YANKEE ATOMIC ELECTRIC COMPANY

November 15, 1990
BYR 90-150

Subject: Response to NRC Request for Additional Information Regarding
the YNPS Severe Accident Closure Submittal

Figure 1

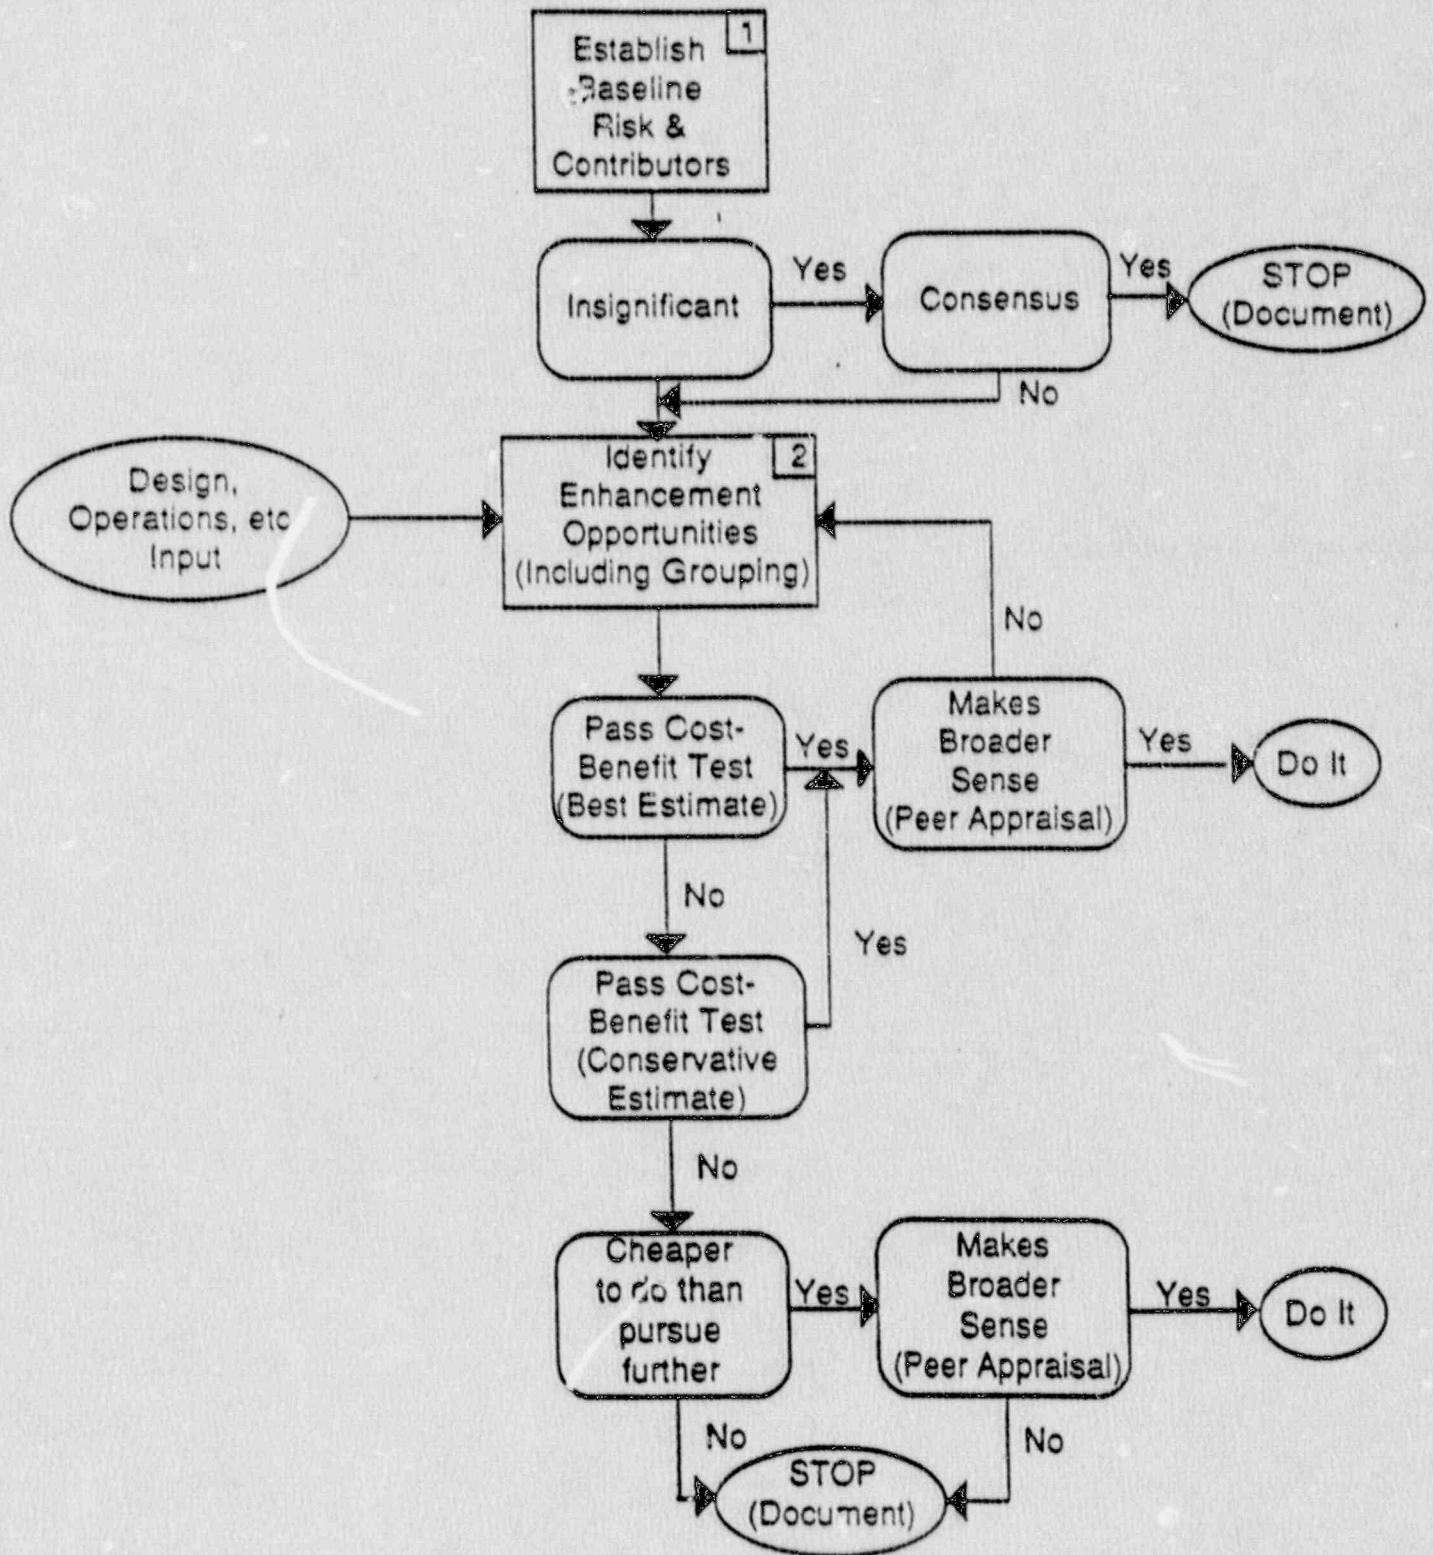
(A) Define core damage as used in the Yankee IPE. (B) Provide a description of how vulnerabilities were defined and identified. (C) Discuss the fundamental causes of any vulnerabilities identified. (D) List the core damage and containment failure sequences that were selected by the screening criteria (Appendix 2) of Generic Letter 88-20. (E) Provide a concise discussion of the level at which the criteria were applied (e.g., system or train).

The decision process on whether an identified potential change is warranted is depicted in Figure 1 and the criteria are detailed in Table 1.
